City of Phoenix

PLANNING & DEVELOPMENT DEPARTMENT

Subject: ITEM 68 ON THE FEBRUARY 3, 2016 FORMAL AGENDA – REQUEST TO ADD STIPULATIONS FOR EMERALD BAY SENIOR LIVING PUD, Z-50-15-2 (G-6129)

Second Floor Window Exhibit

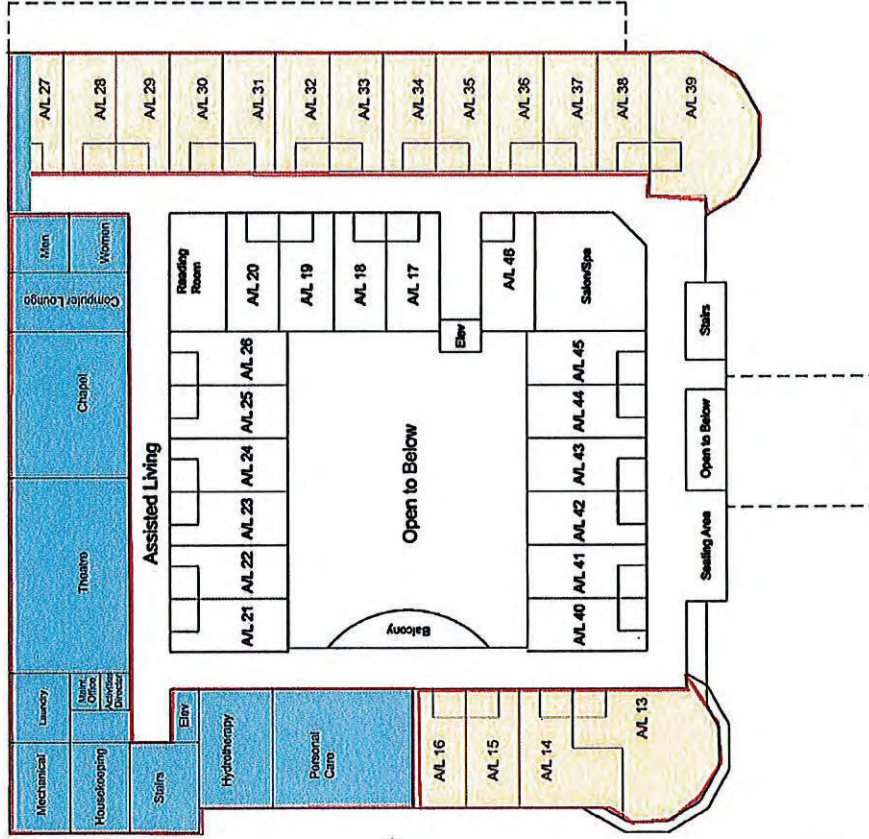
"NORTH AND WEST ELEVATIONS:
ONLY CLERESTORY OR OPAQUE WINDOWS SHALL BE PERMITTED ON THE SECOND FLOOR OF THE BUILDING, FACING NORTH AND WEST, TO PREVENT VIEWS INTO THE NEIGHBORHOOD AS SHOWN IN BLUE ON APPENDIX 6, SECOND FLOOR WINDOW EXHIBIT DATE STAMPED FEBRUARY 3, 2016."

- (1) ADD THE MAXIMUM 25-FOOT BUILDING HEIGHT, AS MEASURED PER THE ZONING ORDINANCE STANDARDS.
- (2) REVISE THE WEST SIDE ELEVATIONS TO INCLUDE EITHER CLERESTORY OR OPAQUE WINDOWS ON THE SECOND FLOOR OF THE BUILDING, TO BE CONSISTENT WITH THE BLUE AREA ON THE SECOND FLOOR WINDOW EXHIBIT DATE STAMPED FEBRUARY 3, 2016.
- (3) REVISE THE STREETScape IMAGES TO REPLACE THE SIX-FOOT HIGH WALL ALONG GREENWAY ROAD WITH A THREE TO FOUR-FOOT HIGH WALL.

*Only Clerestory or Opaque Windows
